GREENBELT STRUCTURAL SERVICES
A DIVISION OF TAHI LLC

TAHI Services and Greenbelt Structural performed a limited assessment at the above noted property. The purpose of the site visit was to conduct a structural investigation to determine current condition and provide additional recommendations with regards to foundation repairs.

DOCUMENT AND REPAIR PLAN REVIEW

Detail Plan

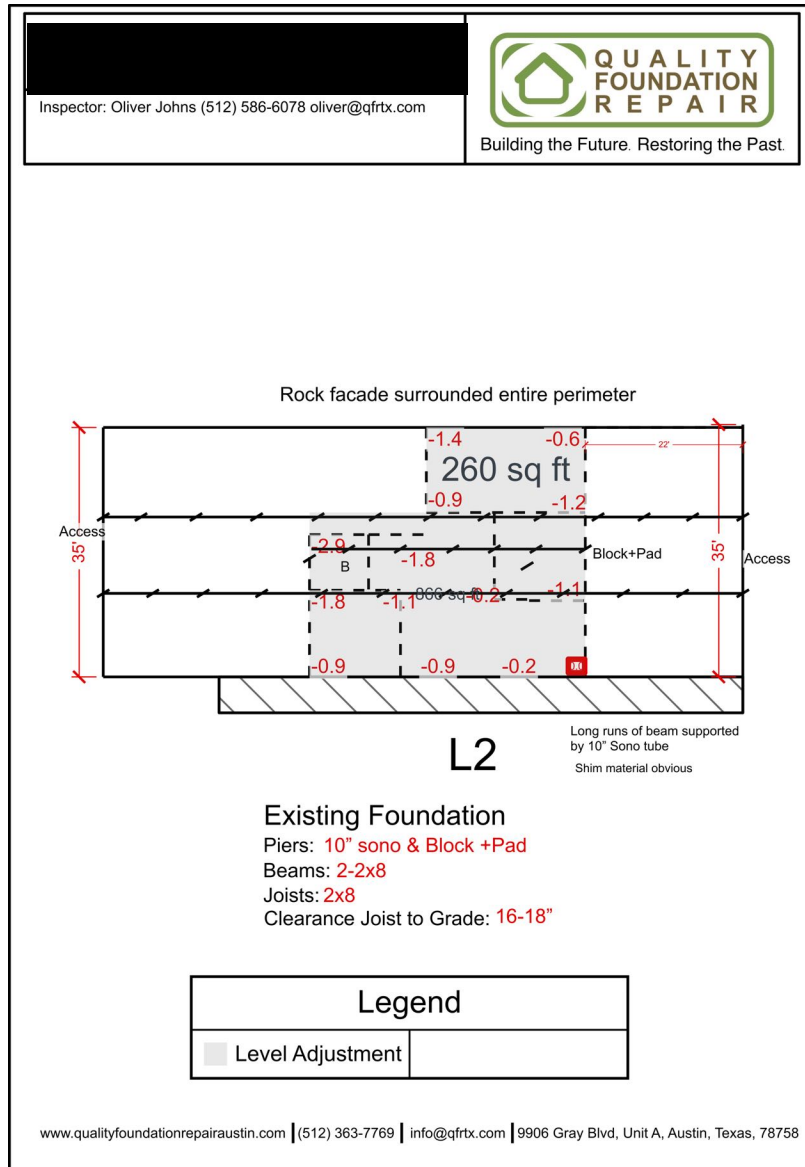
Review of a repair plan provided by Quality Foundation Repair took place (see below for details). Recommendations included in the 'Action Items' section below are in addition to the suggested scope of work provided by Quality Foundation Repair all repair work should meet jurisdictional and industry standards. 3rd party evaluation of the project and engineers letters should be provided during/after the repair project.

NOTE: Recommendations included in the 'Action Items' section below are in addition to the suggested scope of work provided by Quality Foundation Repair all repair work should meet jurisdictional and industry standards. 3rd party evaluation of the project and engineers letters should be provided during/ after the repair project.

Foundation Level Surveys

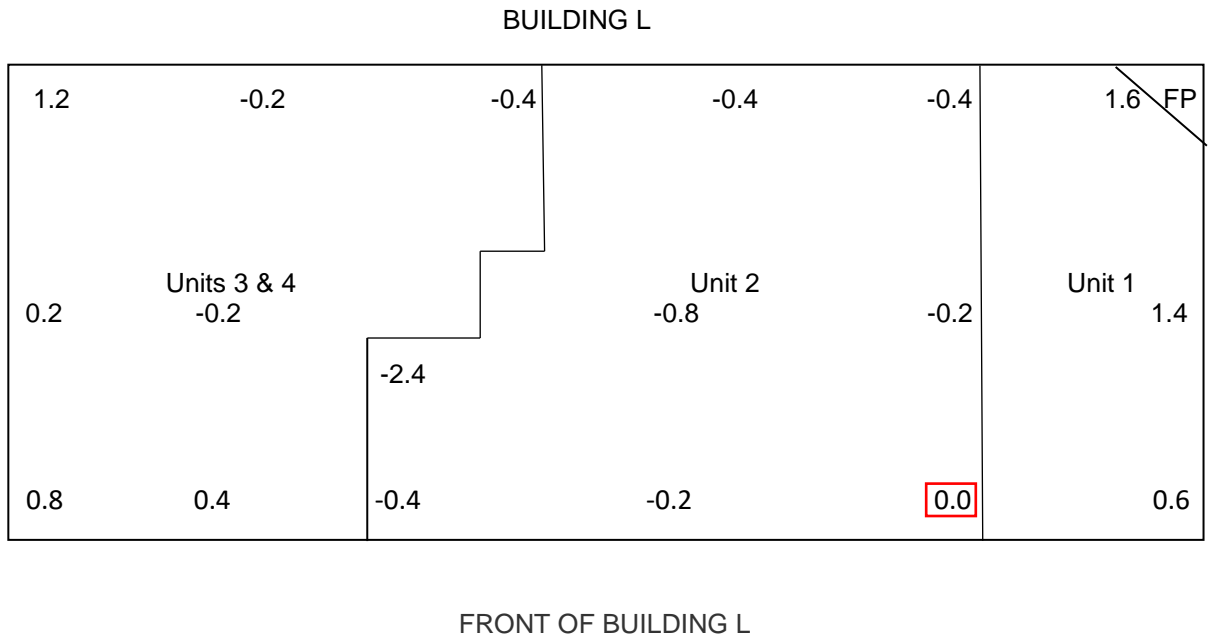
The following foundation levelness survey is measured to the nearest 1/10th inch. All readings are the variances from the 0.0 in the read boxes. The surveys showed the overall variances in the levelness of the foundations to be larger than normal parameters for a foundation of this size. Larger than normal variances were also found in relatively short distances between some of the check points.

GENERAL PIER/BEAM PLAN

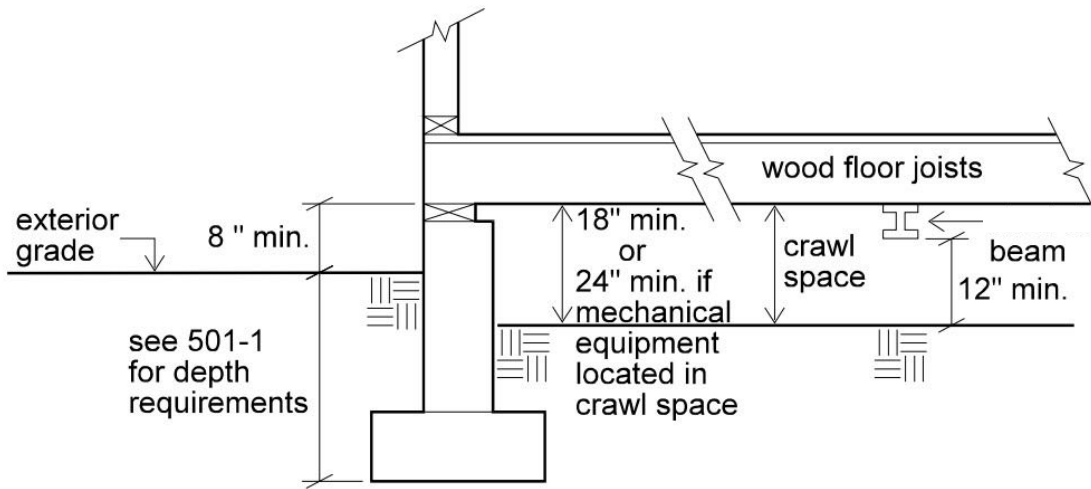
ACTION ITEM	DESCRIPTION / RECOMMENDATION
Dead Load Support	Priority: High Observations of interior walls revealed areas of elevated shifting and functional phenomena (likely a result of insufficient load support). Recommend repair contractor further evaluate the location of interior walls to ensure pier/beam improvements provide continuous load paths throughout (our firm had limited access to interior portions of the building).
Added Interior Pier/Beam	Priority: High Continuation of of the added center pier and beam system or similar improvements (per the direction of the repair contractor) should take place.
Beam Stress Damage	Priority: Mid - High The addition of piers, shims, or other improvements to address interior floor deflection should take place as needed.
Drainage	Priority: Mid Recommend drainage improvements in conjunction with foundation repair. Ensure a proper path of moisture diversion is present throughout the site (divert run-off to impervious coverage at parking or per the direction of a drainage specialist).

SILL PLATE UPLIFT

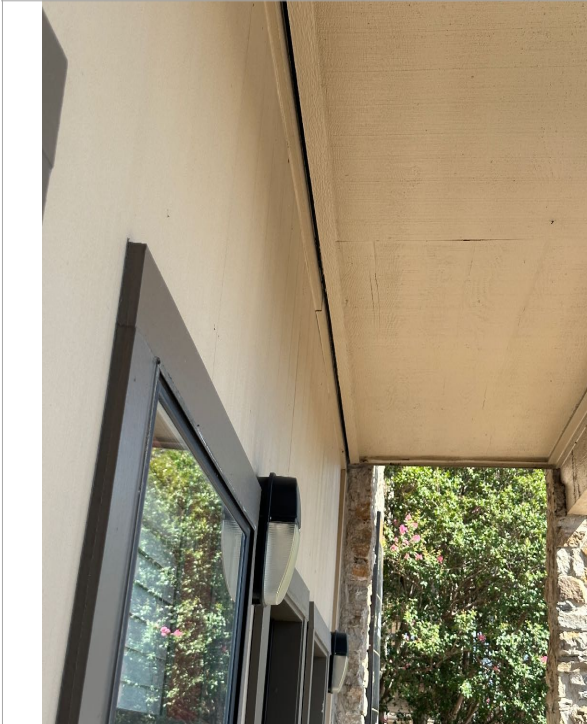
Upon entry at the right side of the building, we observed substantial lifting of the sill plate. The inside edge of the sill was lifted by up to 1 1/2". From our vantage, we did not observe any anchors or other method of connection between the sill and perimeter beam wall. No steel straps or other common connectors were present at interior piers and beams. Evidence of previous shimming and repair/improvements at interior piers and beams was noted. The installation of an additional pier/beam system was present at the mid/center portion of the crawlspace.
